Preliminary Field Check For Drip Systems

COMAL COUNTY

Address: 10409 Verona Blvd.

Legal Description: Contessa Unit 1

SSSF SOIL EVALUATION FORM

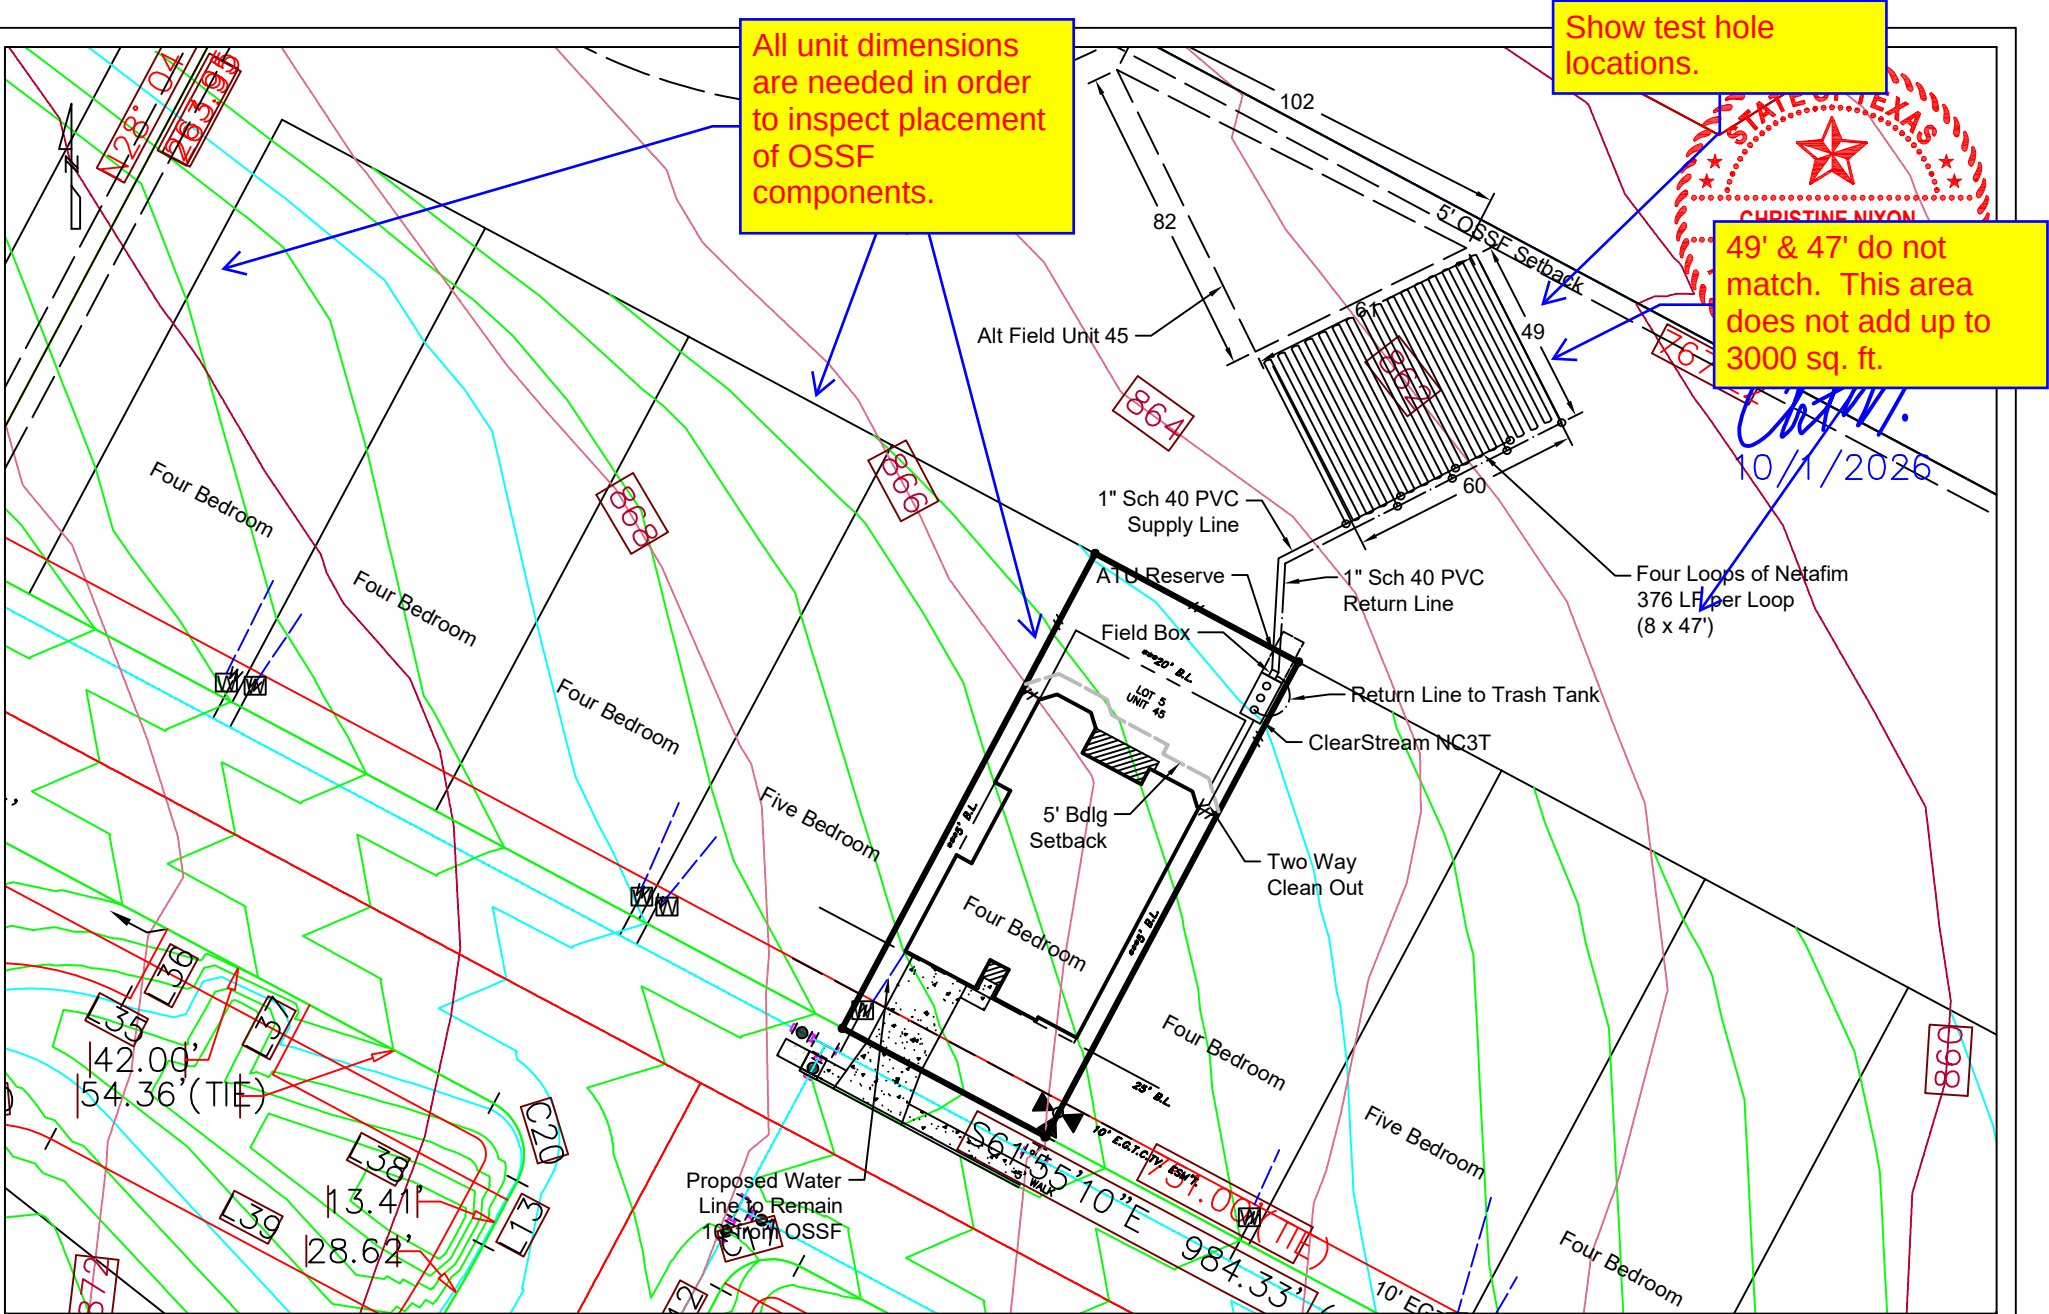
Indicate site specific location.

Soil evaluation incomplete.

Preliminary inspection will be completed. Additional comments may be necessary.

Burrier Nixon Engineers	10409 Verona Blvd. Lot 5, House/Unit 45 New Braunfels, TX Comal County
	Scale 1"=50'

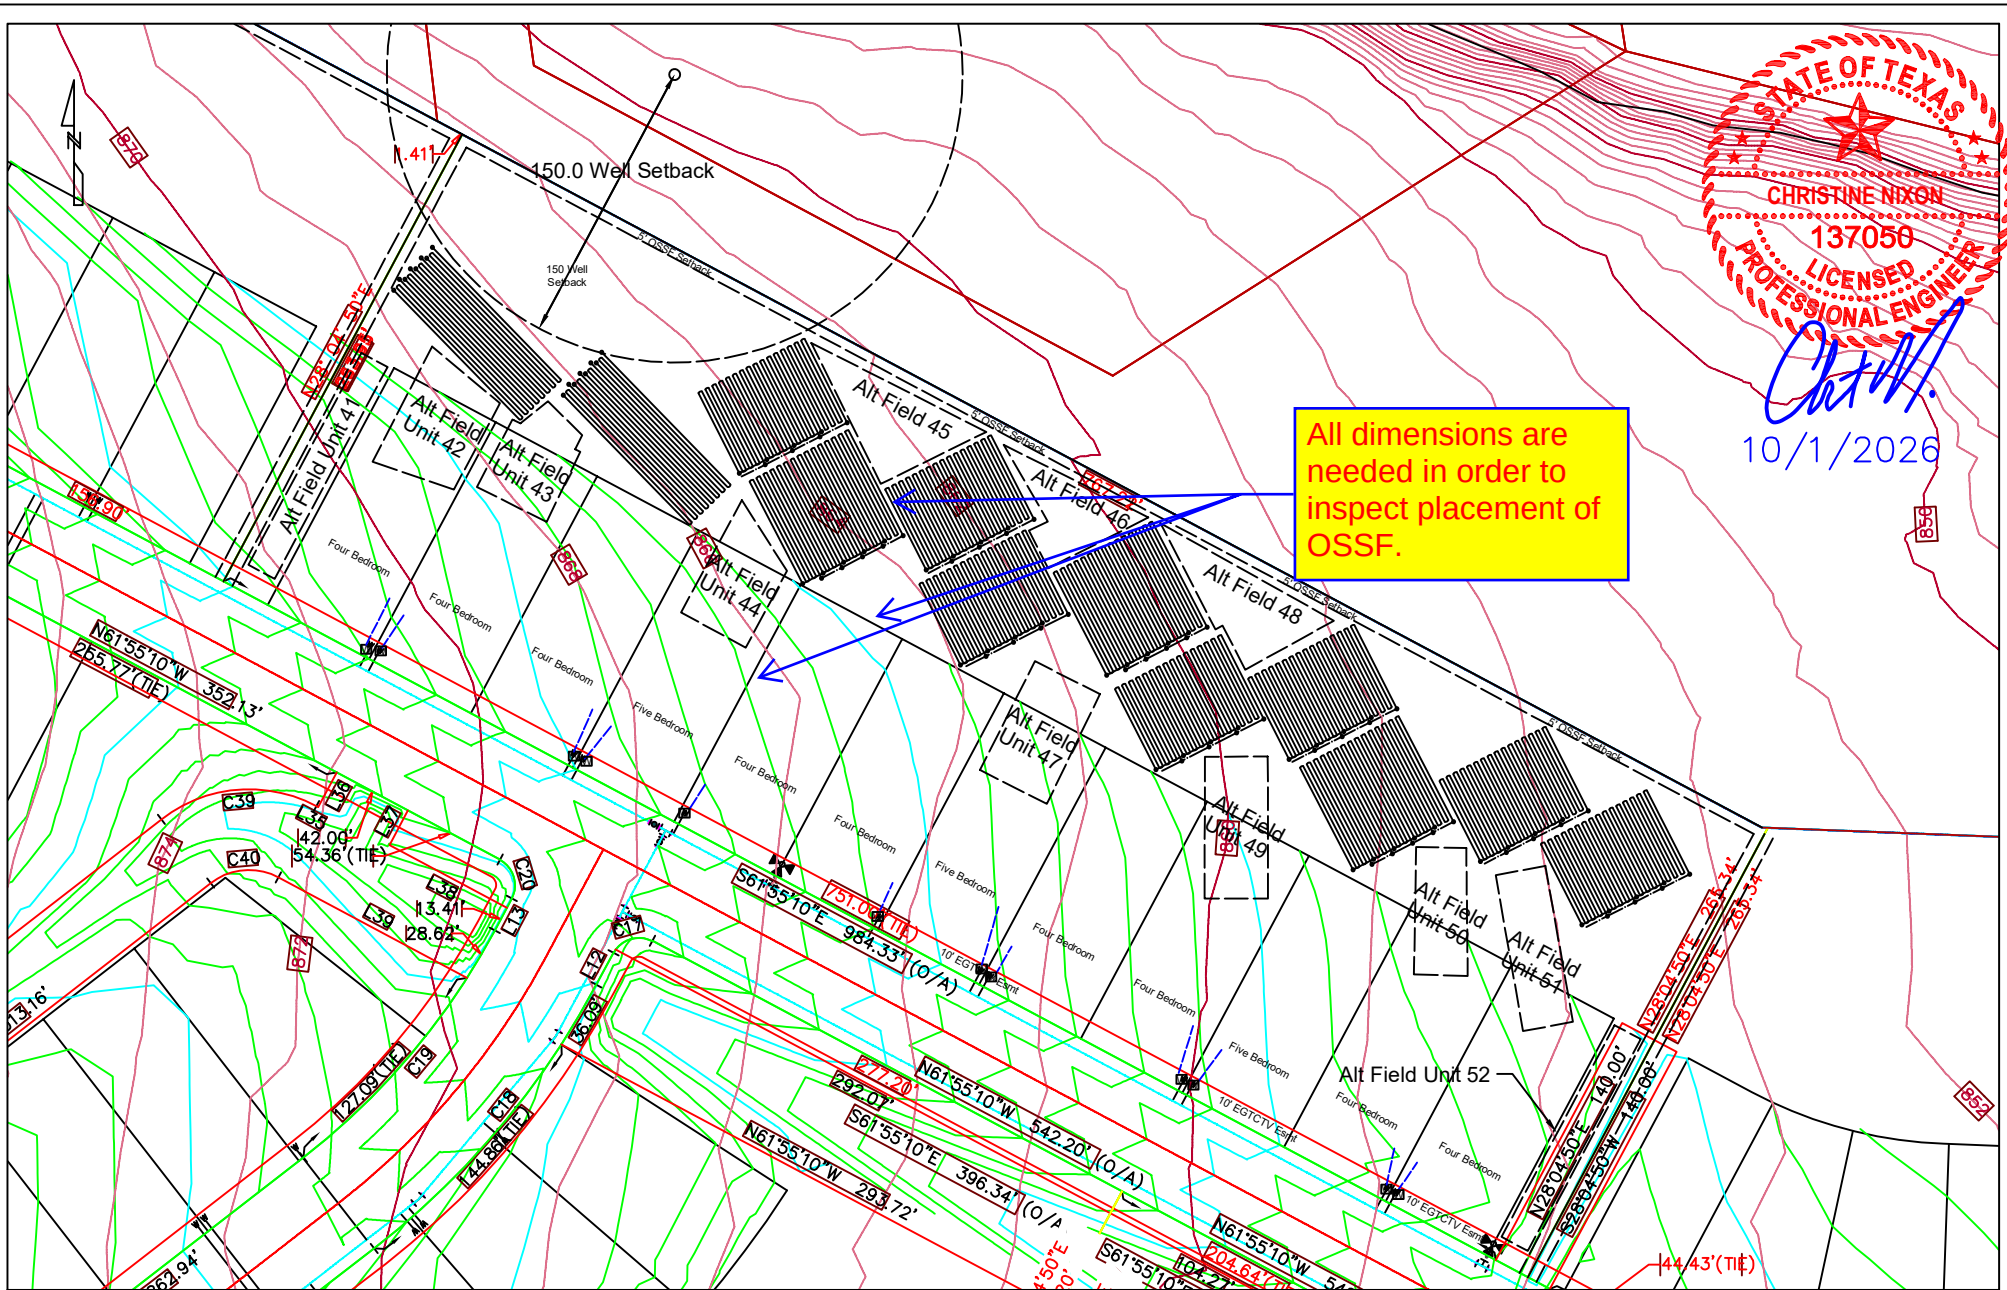
All unit dimensions are needed in order to inspect placement of OSSF components.

Show test hole locations.

49' & 47' do not match. This area does not add up to 3000 sq. ft.
